2 Type of change

The marking on the socket of the fuseholder changes. The new marking includes VDE according IEC with rated voltage and cURus according UL/CSA with rated voltage and rated current.

FBS2					0118.2292	
creation date	created by	release date	released by	notification no.	revision	page
2015-07-06	dislercy	2015-08-19	dislercy		-	1 of 1

Old marking	New marking

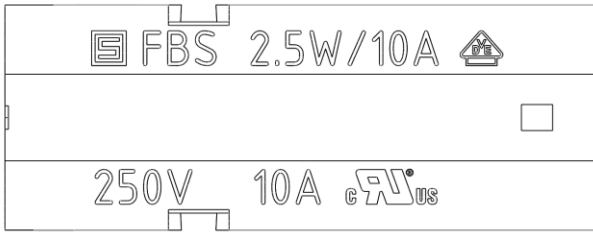
Old marking	New marking
FBS VDE 2.5W/10A cURus 250V 10A	FBS2 VDE 250V cURus 250V 10A

Correction of fuseholder marking.
